PROJECT
RYLANDS BUILDING, MANCHESTER

TITLE
COMPARISON PLAN SUB BASEMENT

JOB No	DWG No	REV
1526	AL[05]4210	*

ISSUE FOR
PLANNING DOCUMENT

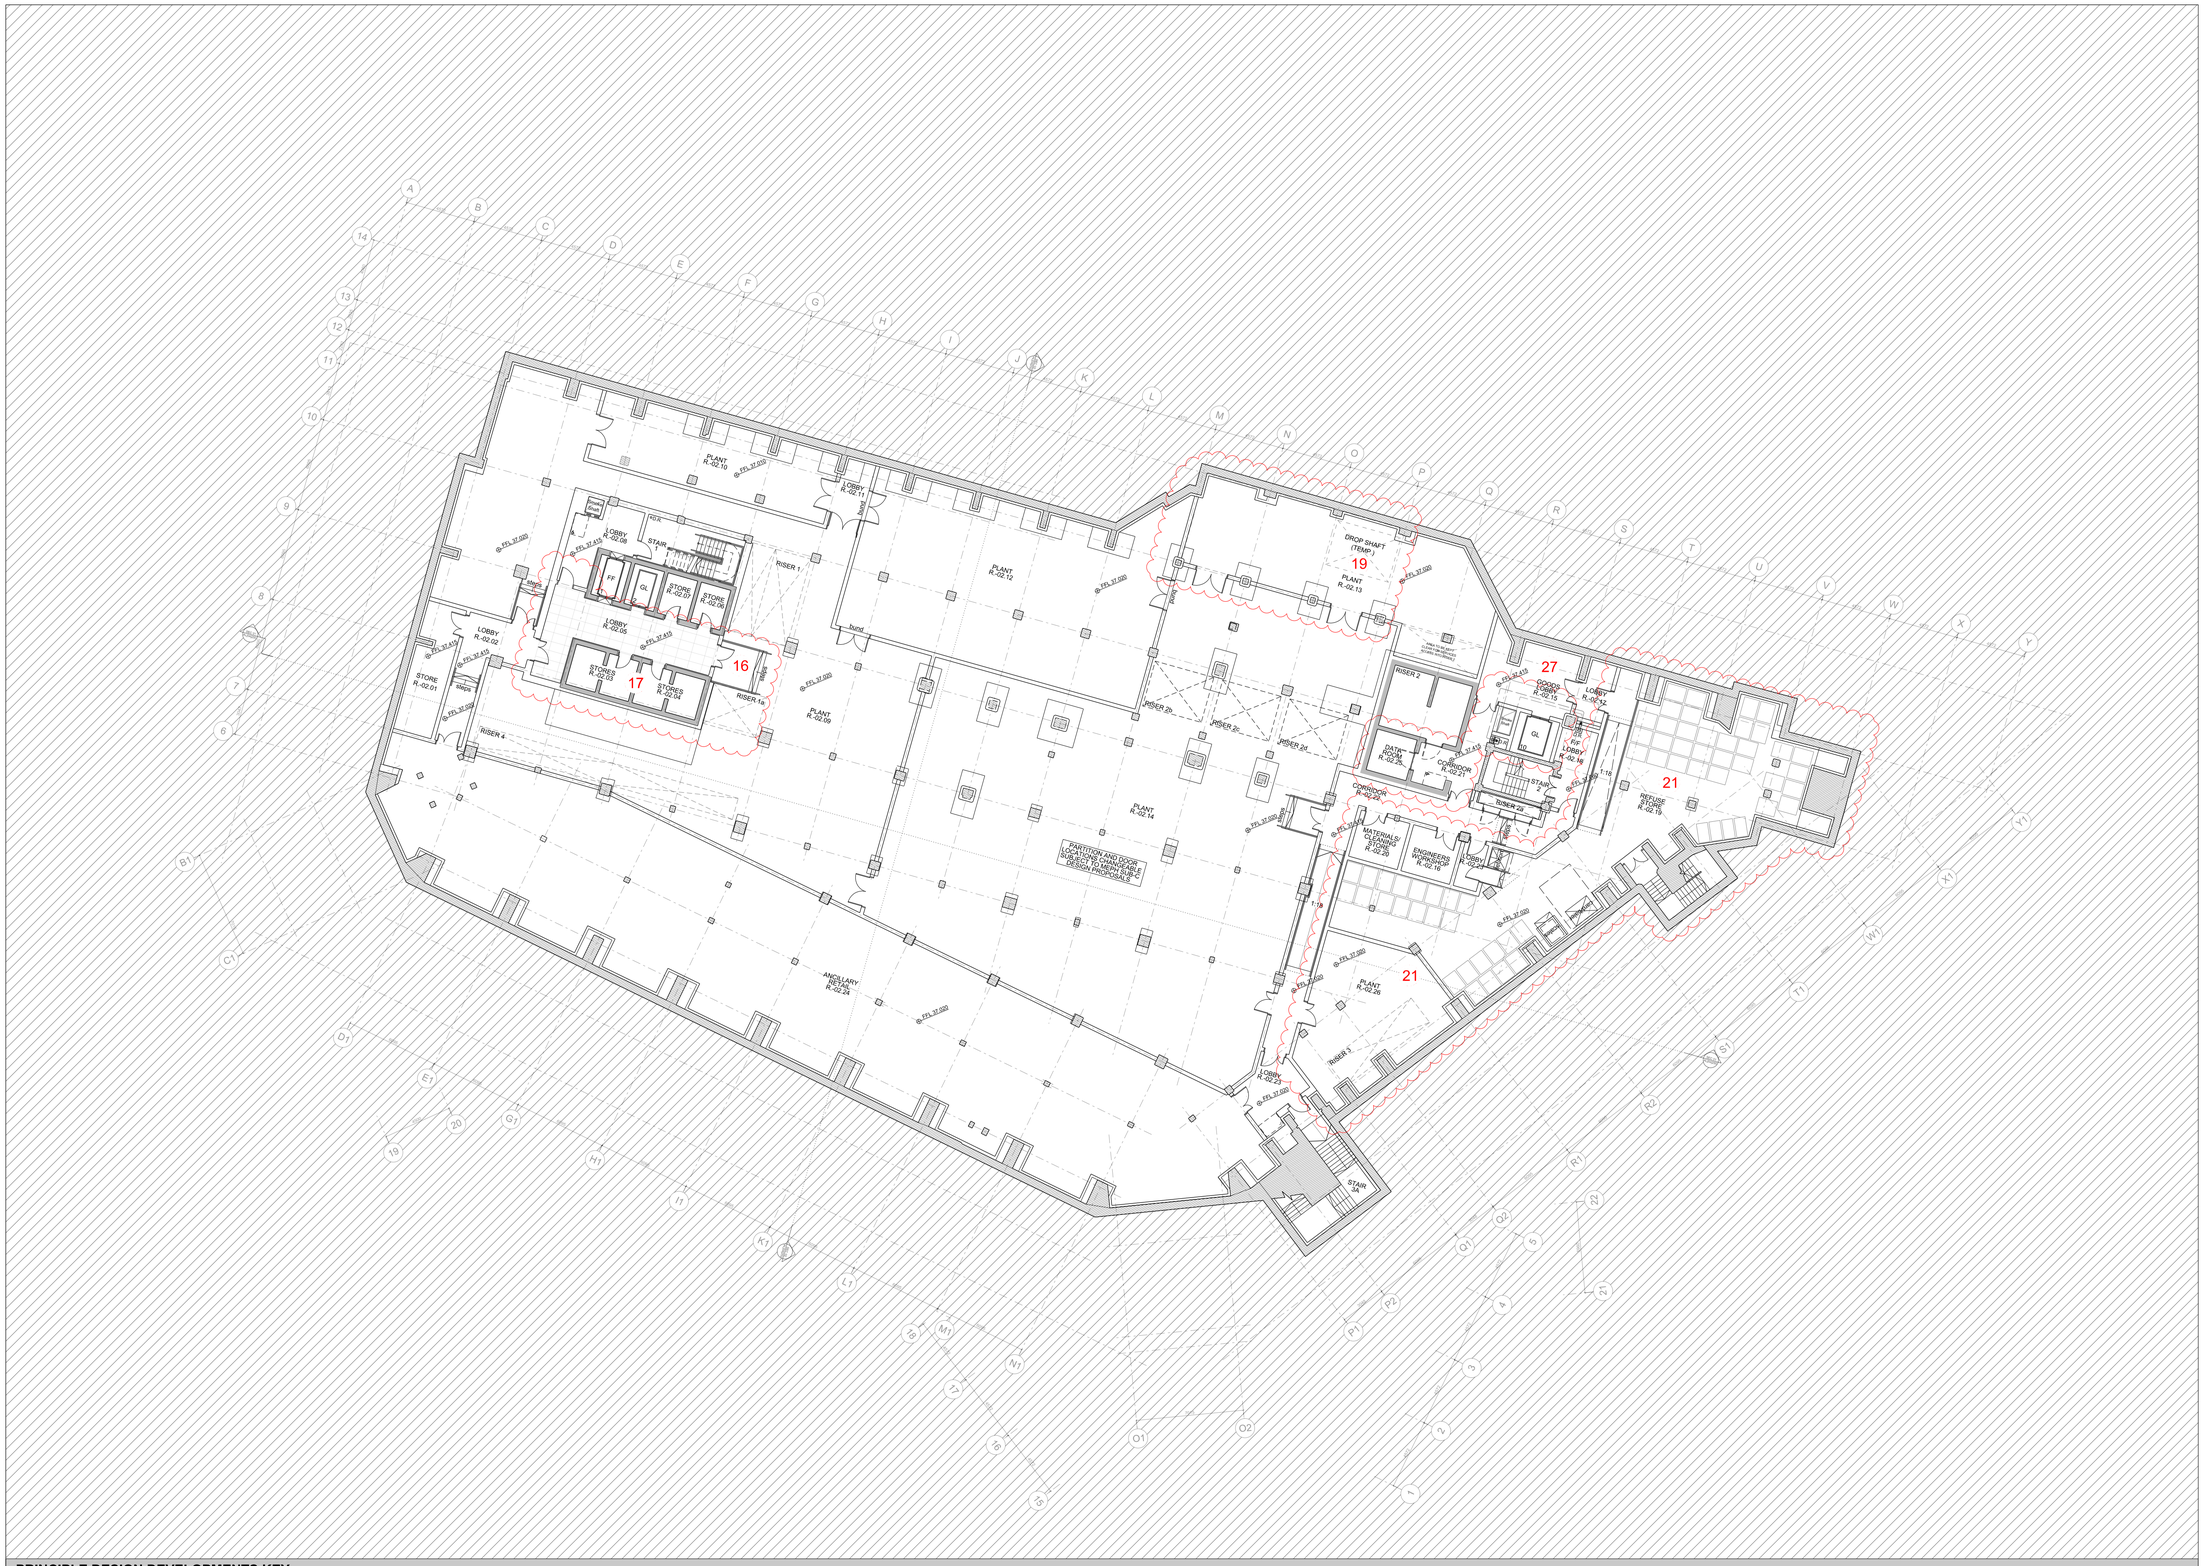
1. Double-mullions & Parallel Opening Vents omitted from extension elevations
2. Saw-tooth roof profiles reduced in number & length. Sawtooth structures to carry PV panels only, thermal envelope now at roof slab level.

3. Core 2 lift overrun height lowered within Roof Plant enclosure due to VRF MEP strategy.
4. Glazing sections to Atrium simplified.
5. Terrace 7A omitted. New back-painted glass screen to accommodate new VRF MEP servicing strategy at existing roof level. PPC vent louvres to lid, & to base of West elev, concealed behind main stone parapet.

6. New Market Hall Unit & revised Office Foyer at Ground Floor Level
7. Lower floors replanned (see notes on General Arrangement plan drawings).
8. Overall height remains unchanged from the consented scheme.

9. Roof-plant enclosure reduced in width & lengthened to GL. H to accom. VRF MEP strategy. PPC vent louvres to base of South & North elevs concealed by sawtooths.

10. Double-mullions omitted from Shop-front glazing
11. New fire exits required to Shopfronts for Market Hall use
12. New Market Hall entrance door arrangements

13. Updated Cycle-store entrance and exit arrangements
14. Back-painted glass in glazed facade system to match main facade system - Profiled metal cladding omitted.

15. Lift overrun wall widened to conceal adjacent plant.
16. Protected Lobby update.
17. Store area adjusted.
18. Lift 8 omitted. Void/Store/tbc
19. Drop shaft relocated.

20. Facilities Management & General Back of House areas updated to accommodate Market Hall.
21. Plant and bin store arrangement updated to accommodate Market Hall.

22. Lobby arrangement to increase locker provision within changing
23. Cycle lift & ramp omitted for new cycle-stair, reducing structural impact
24. Continuity of EXTG Floor area (hatched) subject to investigation - possibly ground bearing slab at high level

25. Updated lobby & stair entrance preserving more of existing building fabric.
26. Lobby arrangement to increase in area.
27. Core 2 Lift functions & service levels rationalised for efficiency

28. Ramp external to Stair 3 lobby
29. Equipment Room provided.
30. Rooflights rationalised into singular rooflight
31. Cleaning facilities provision updated.

32. WC added.
33. Extg balconies refurbed for reuse.
34. Winter Garden omitted.
35. External fabric amendment to accommodate existing structure.
36. Existing doorway retained, new door fitted to match new adjacent.

37. Security bollards to Bridgewater Place entrance.
38. Bird & batbox proposed locations included.
39. Partition line moved to increase commercial space.

40. Green roof to flat roof of L7 link.
41. Ducting terminations in aesthetically coordinated metal sheathing.
42. Renewables omitted @ L7 roof.
43. Horizontal plant-screen fins omitted.

44. Overrun of Lift 10 removed.
